SUBJECT: Westinghouse Responses to NRC Requests for Additional Information

**Westinghouse Non-Proprietary Responses
to Requests for Additional Information
Regarding the AP1000 Pre-Certification Review**

AP1000 PRE-CERTIFICATION REVIEW

REQUEST FOR ADDITIONAL INFORMATION

Figure P59-1: Upper Head Level – 1-inch Cold Leg Break

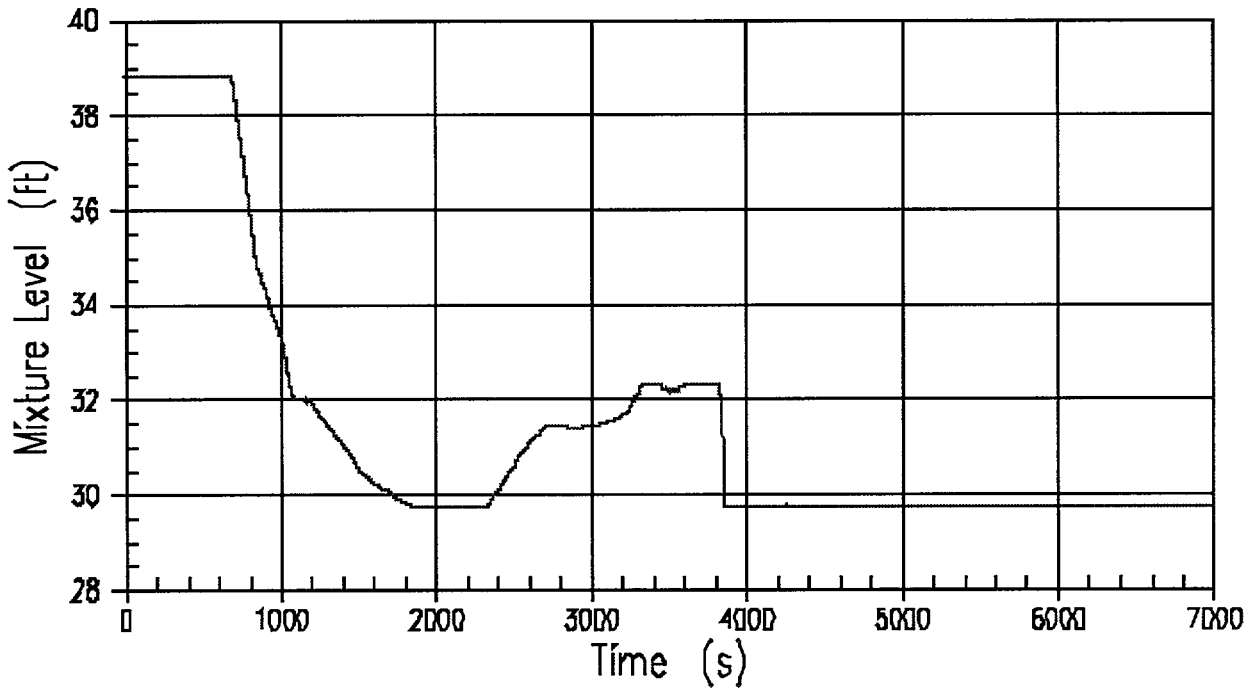
For the one-inch cold leg break, provide figures showing predictions of water levels in the vessel upper head and upper plenum, the accumulators, the CMTs, and the pressurizer. Also, provide a figure showing the core exit flow quality, the steam flow at the core exit, the core inlet flow, the core inlet subcooling and the pressurizer pressure.

Attached please find the requested plots. Note that these plots were generated with our preliminary NOTRUMP model used for the scoping analyses provided in WCAP-15612.
